Appl. No. 10/687,947
Amdt. Dated December 9, 2005
Reply to Office Action of August 10, 2005

Amendments to the Drawings:

REMARKS/ARGUMENTS

FIG. 4(a) **PRIOR ART**

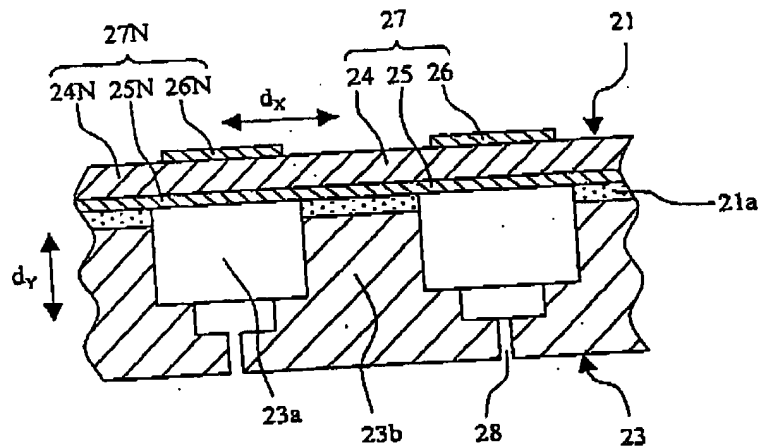
Figures 4(a) and 4(b) stand objected to because the office contends that Figs. 4(a) and 4(b) should be designated with a legend such as --Prior Art--. In response, Applicant has added the legend --Prior Art-- to Fig. 4(a) and Fig. 4(b). Withdrawal of the objection is respectfully requested.

The attached sheet of drawings includes changes to Fig. 4(a) and 4(b). This sheet, which includes only Figs. 4(a) and 4(b), replaces the original sheet. In Figure 4(a) and 4(b), a legend --Prior Art-- has been added.

ADDED
